**GE Energy
Nuclear**

NEDO-33330
Class I
eDRF 0000-0067-1515
September 2007

LICENSING TOPICAL REPORT

Advanced Boiling Water Reactor (ABWR) Hydrogen Recombiner Requirements Elimination

Figure 2.14.8 Flammability Control System

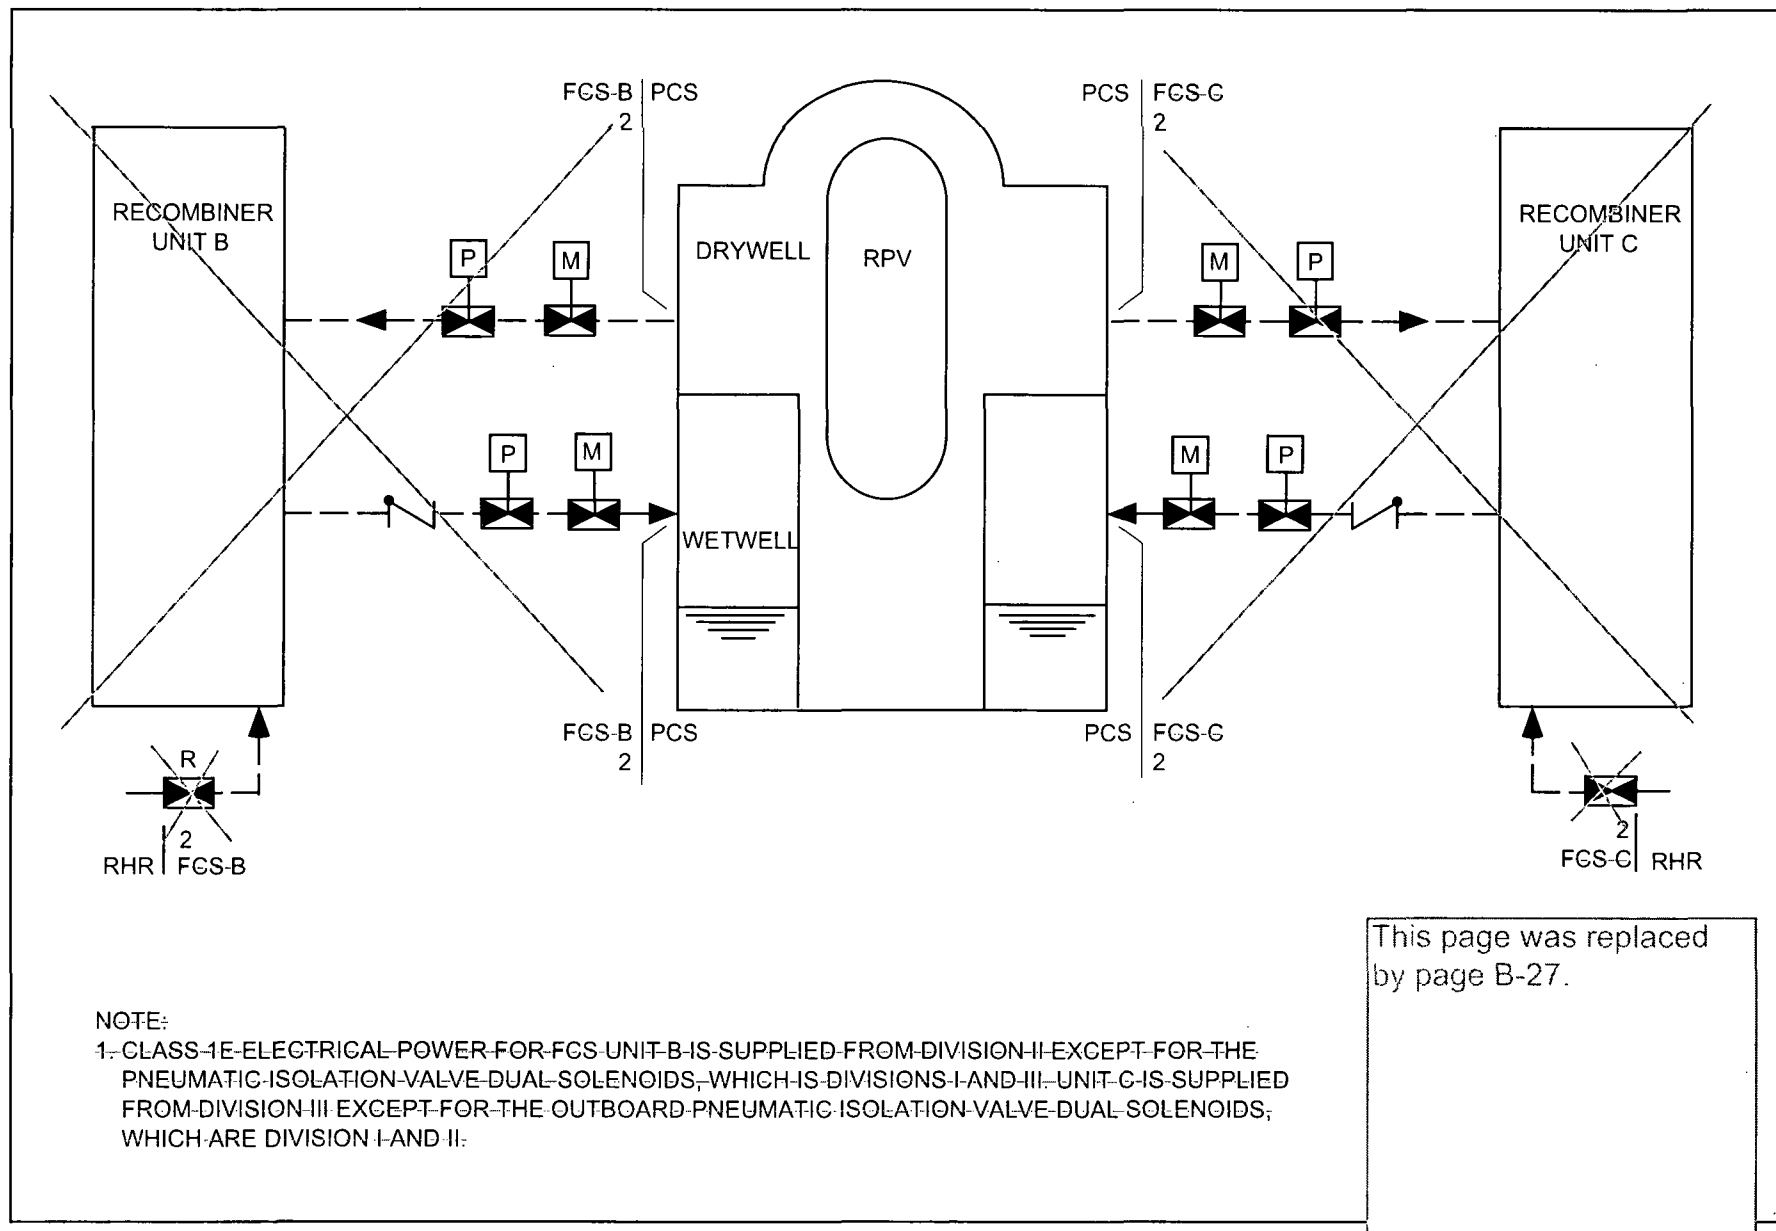
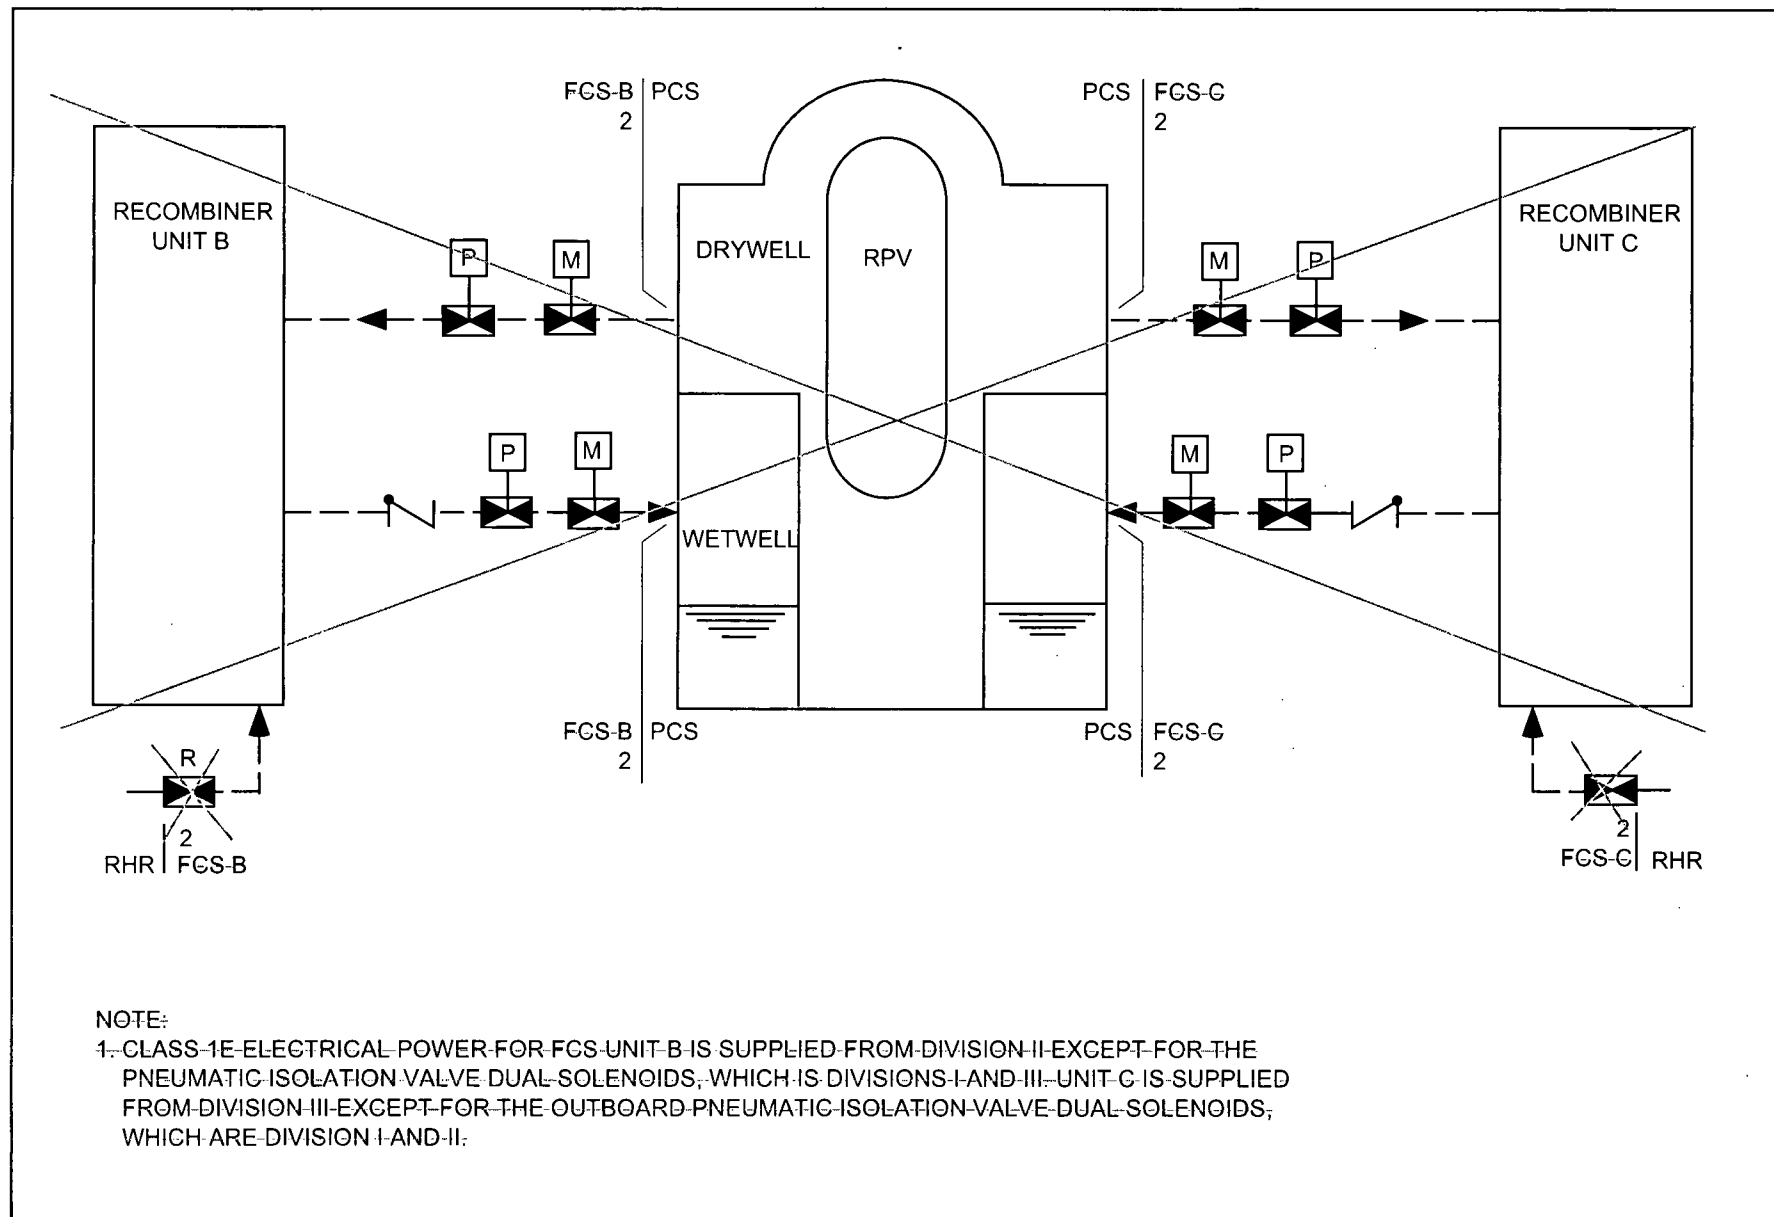
~~The check valves (CVs) shown on Figure 2.14.8 have active safety related functions to both open and closer under system pressure, fluid flow, and temperature conditions.~~

~~The pneumatic valves shown on Figure 2.14.8 fail to the closed position in the event of loss of pneumatic pressure or loss of electrical power to the valve actuating solenoids.~~

~~Inspections, Tests, Analyses and Acceptance Criteria~~

~~Table 2.14.8 provides a definition of the inspections, tests, and/or analyses, together with associated acceptance criteria, which will be undertaken for the FCS.~~

Figure 2.14.8 Not Used

Figure 6.2-41 Hydrogen and Oxygen Concentrations in Containment After Design Basis LOCA

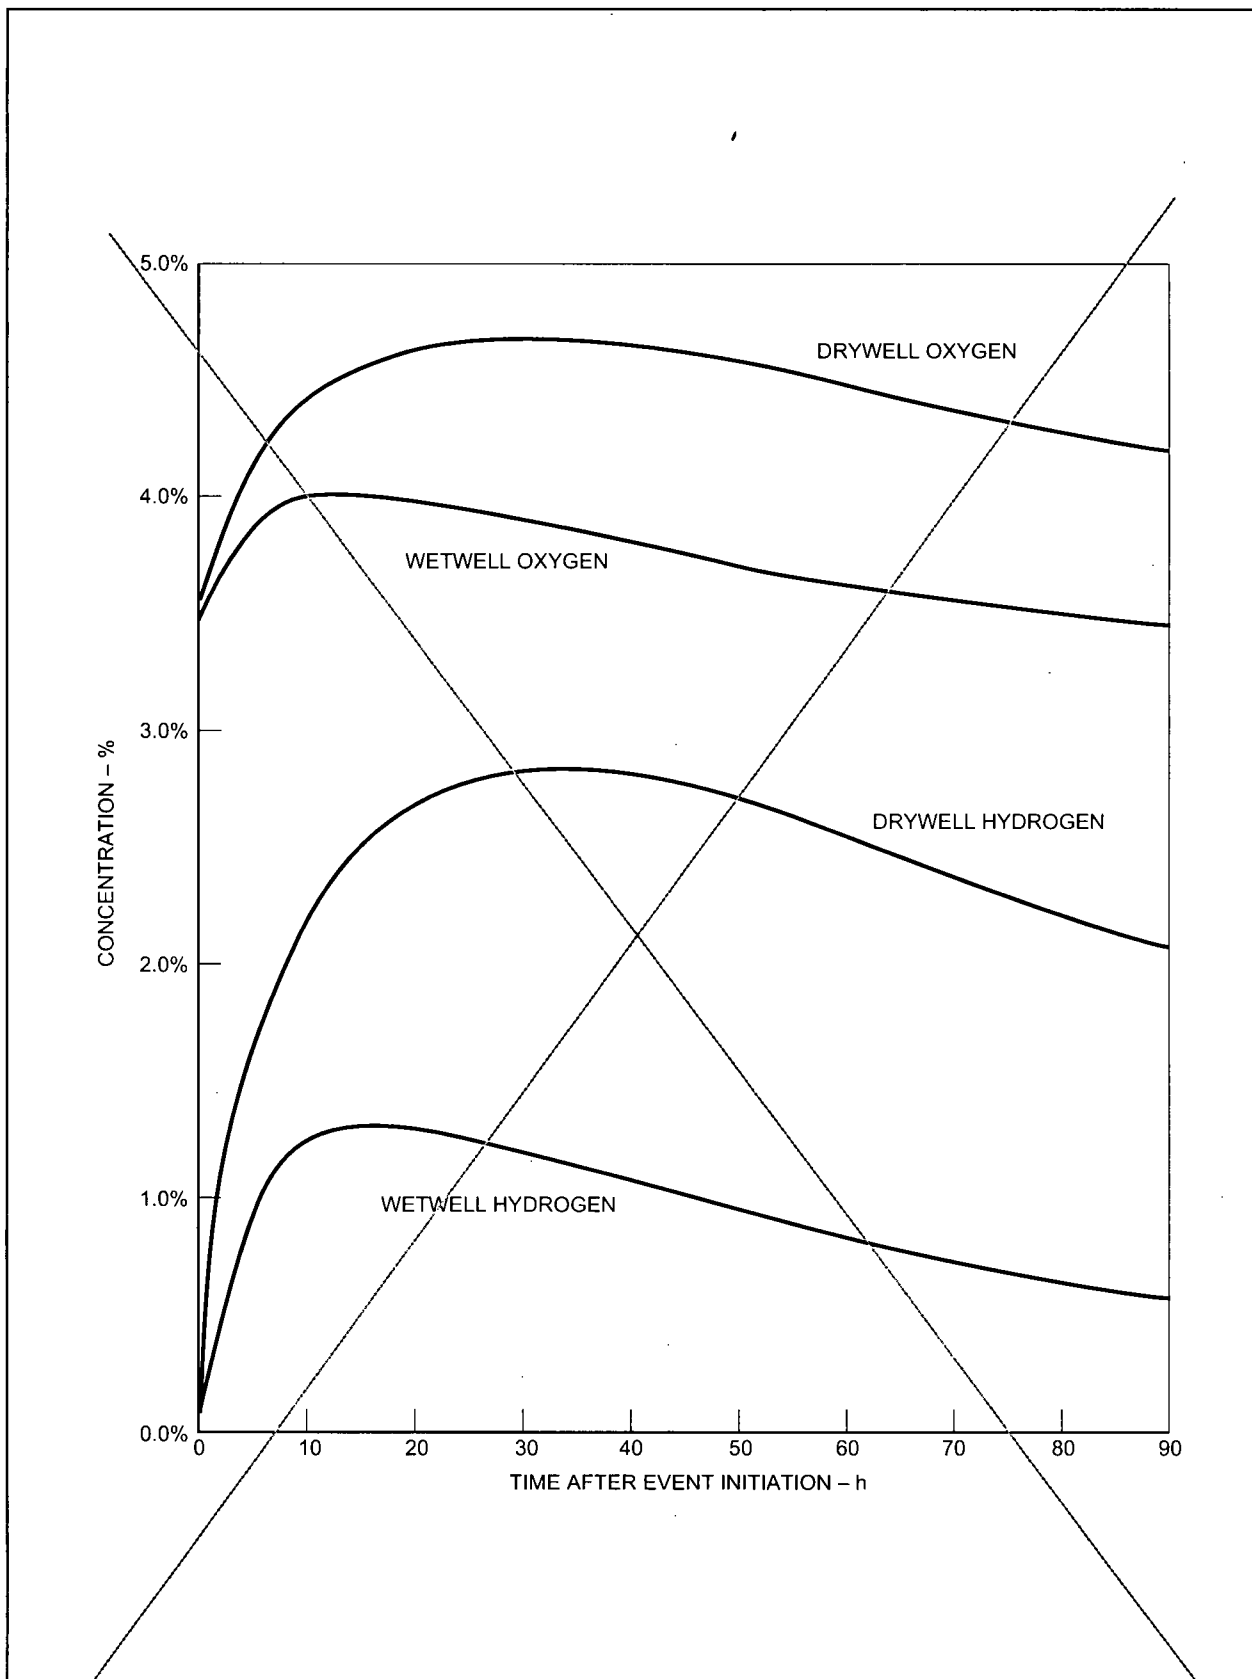
~~Figure 6.2-40 Flammability Control System P&ID (Sheets 1 – 2)~~

This page was
replaced by page
C-187
